ADDENDUM 2 TO ENVIRONMENTAL IMPACT REPORT

Date of Publication of Addendum: March 4, 2026
Date of EIR Certification: June 15, 2017
Case No. **2024-005509ENV**
Project Title: **One Oak Street Project (1500-1540 Market Street)**
Block/Lot: 0836/001, 002, 003, 004, and 005
Project Sponsor: Brynn McKiernan, Emerald Fund, Inc.
(415) 489-1306
Lead Agency: San Francisco Planning Department
Staff Contact: Rachel Schuett – (628) 652-7546
rachel.schuett@sfgov.org

OUTLINE OF FLOOR PLATE AT BALCONY LEVELS (SHOWN DASHED)

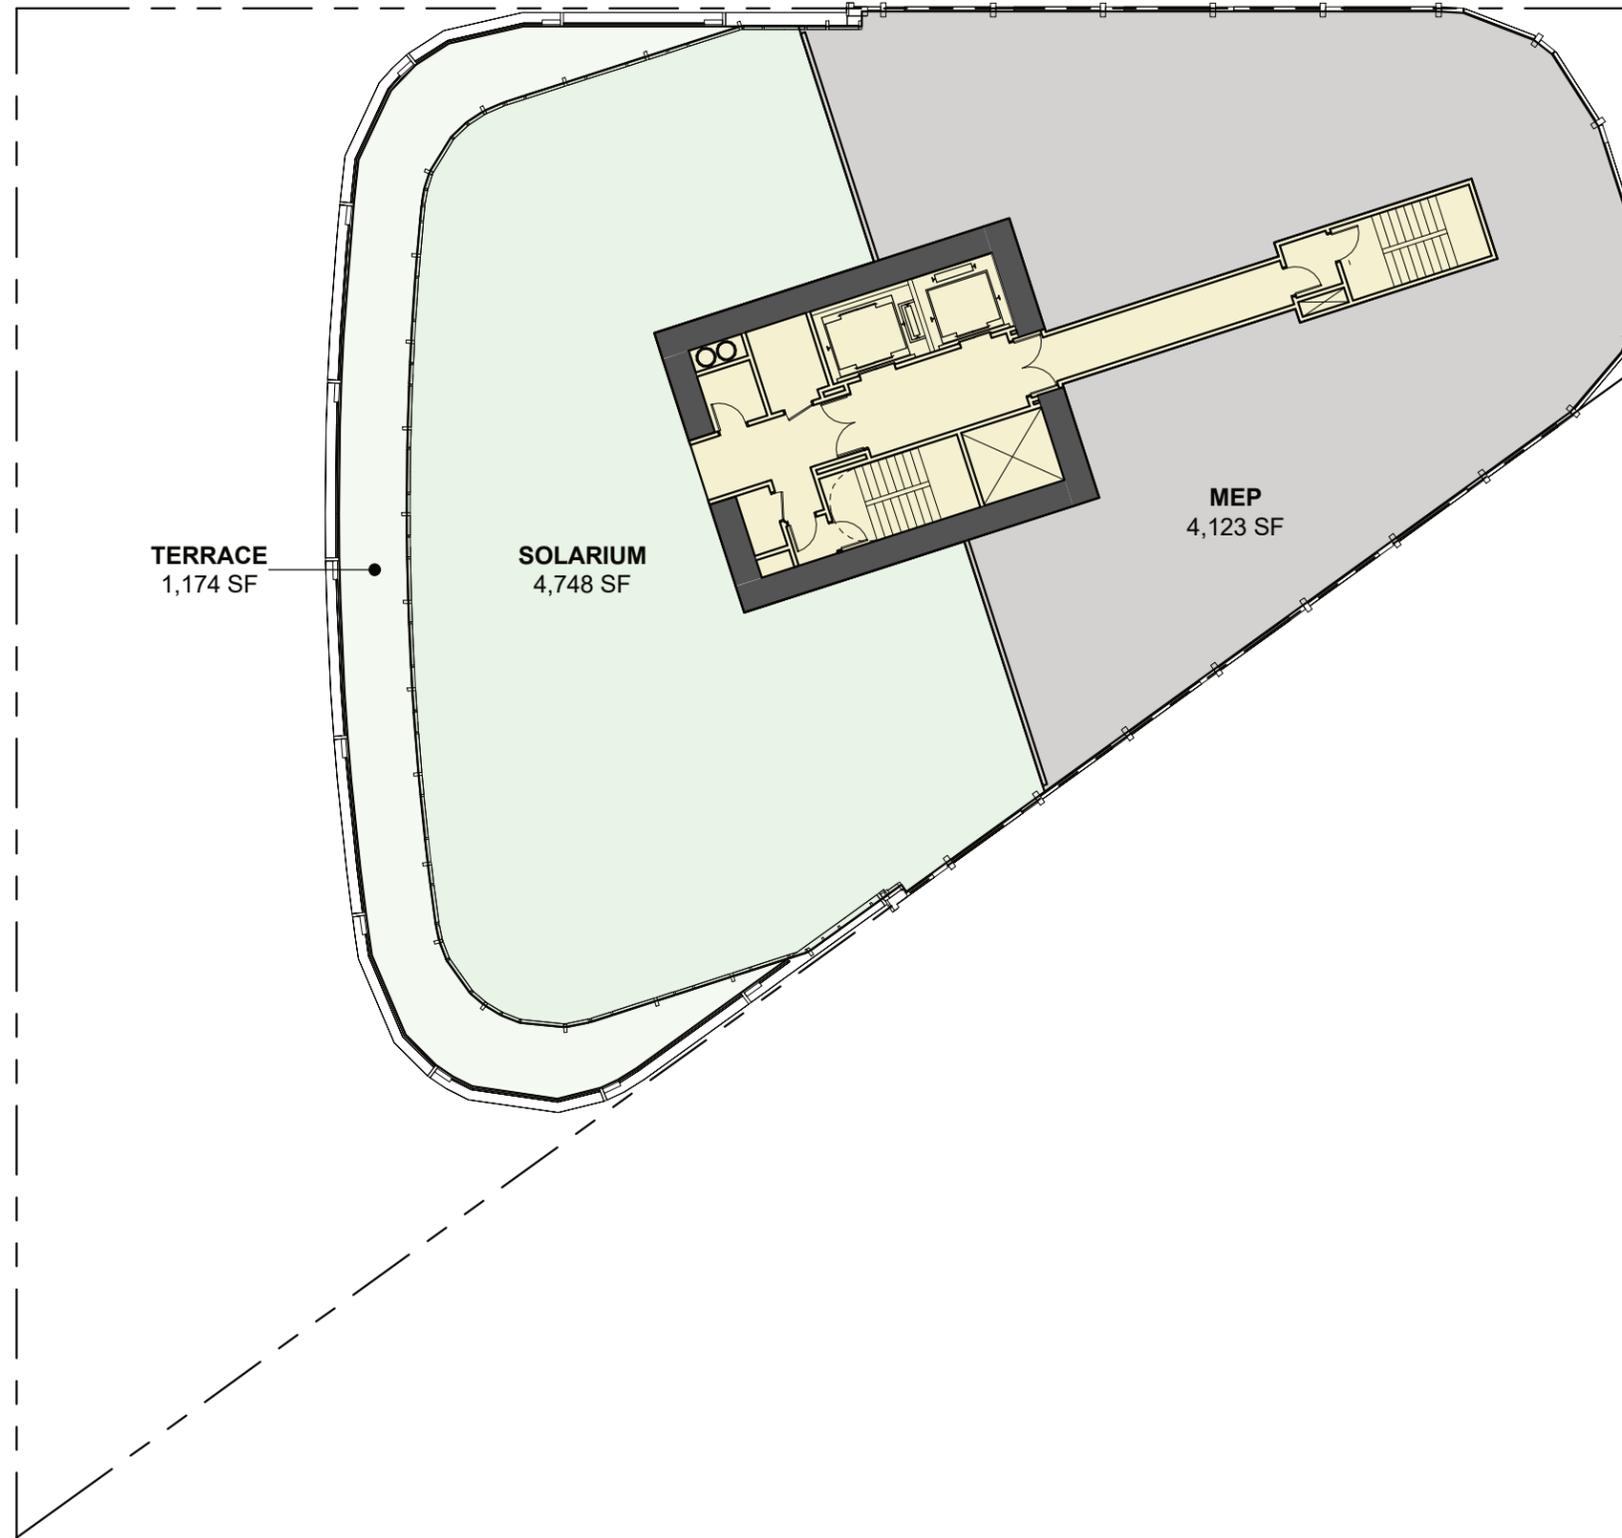
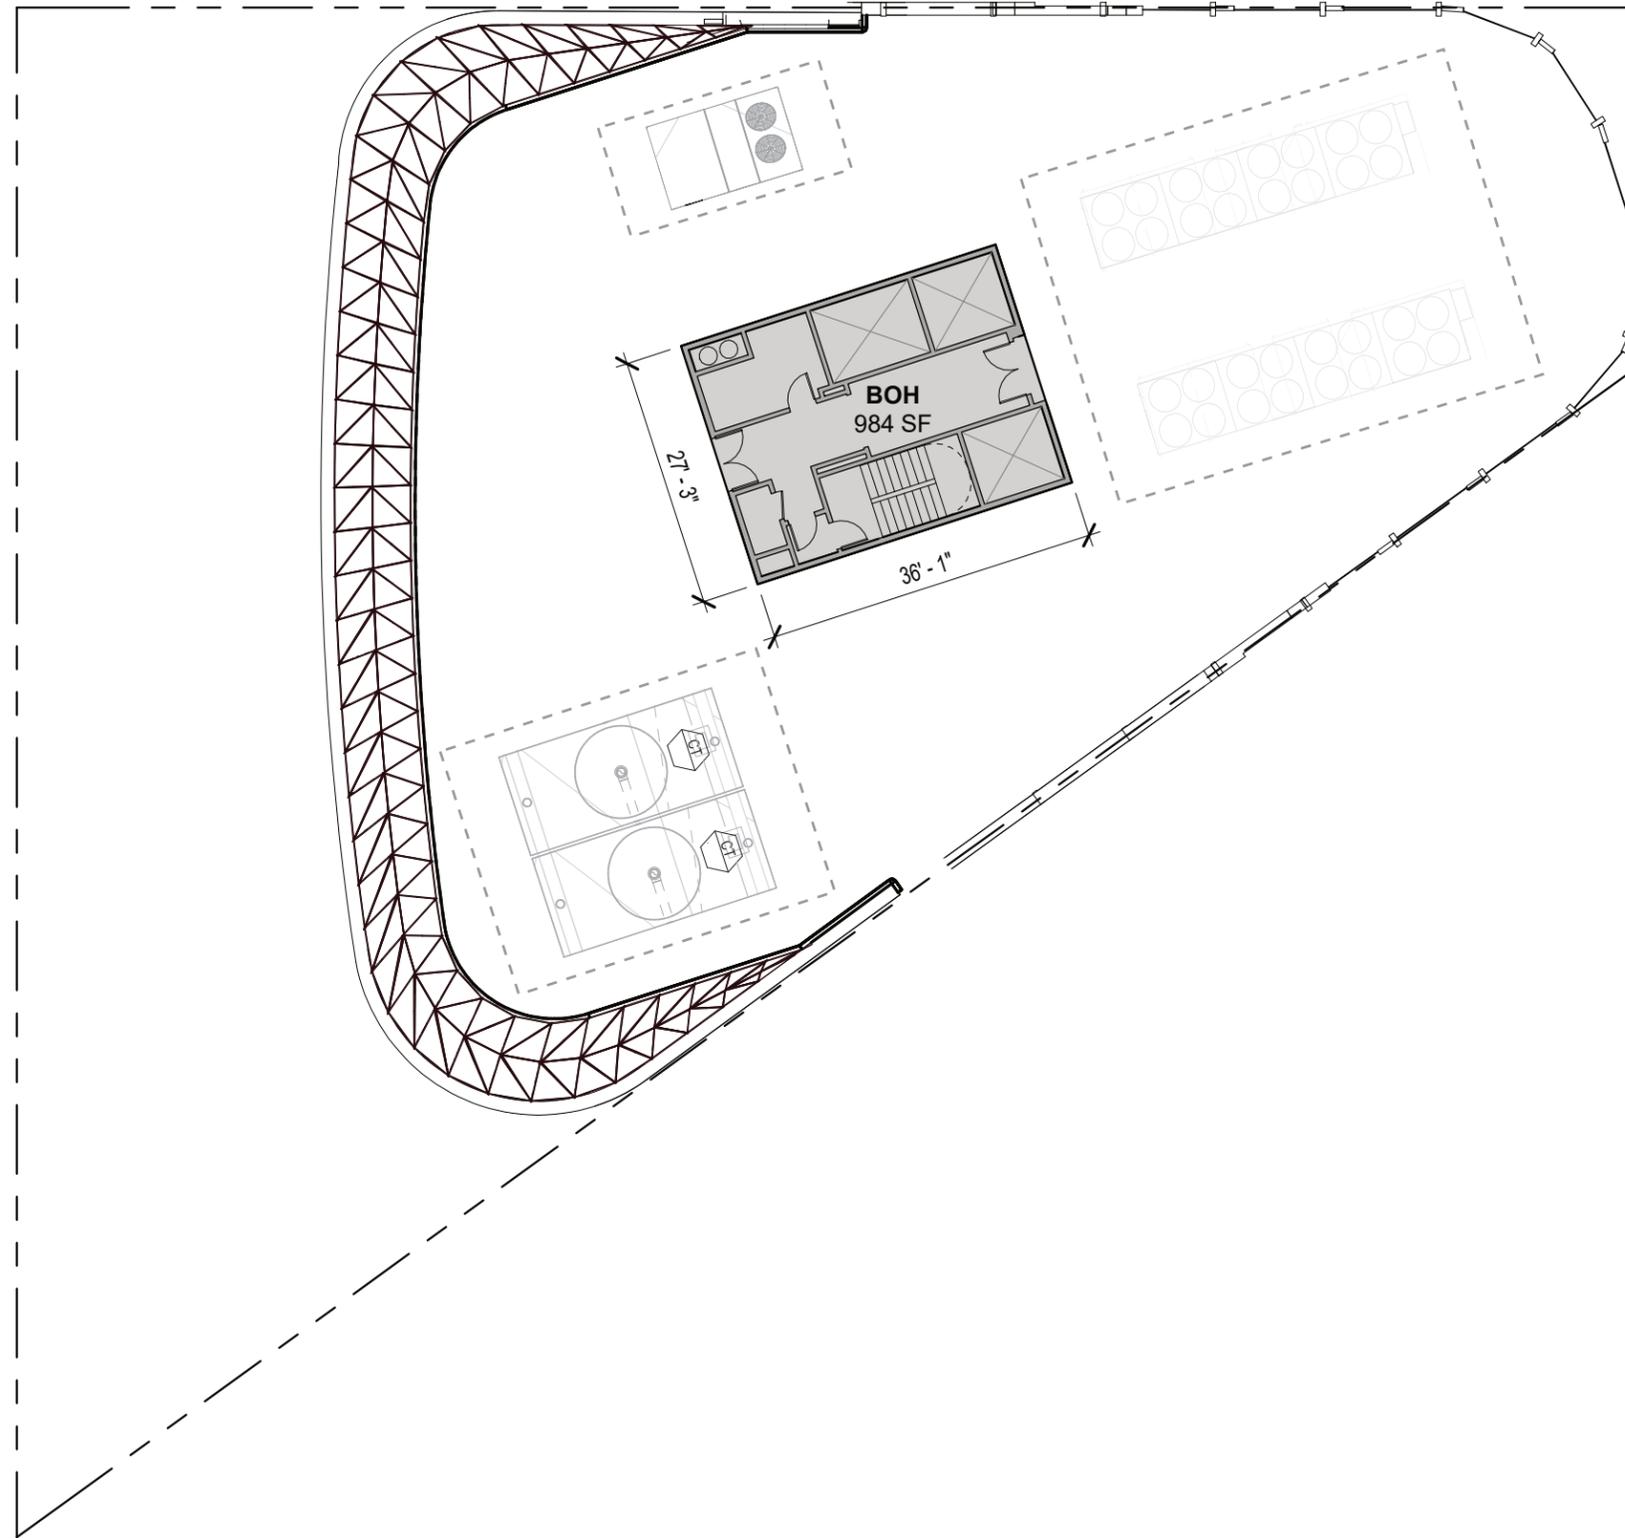
As shown in **Attachment A. Figures**, pp. 24, 39, 44 and 45, the revised project would incorporate the following wind-reducing design features:

INTEGRATED POROUS WIND CANOPY @ 25'-8" ABOVE GRADE. 12' DEEP ALONG OAK STREET AND MARKET STREET, 15' DEEP AT BUILDING'S NOSE
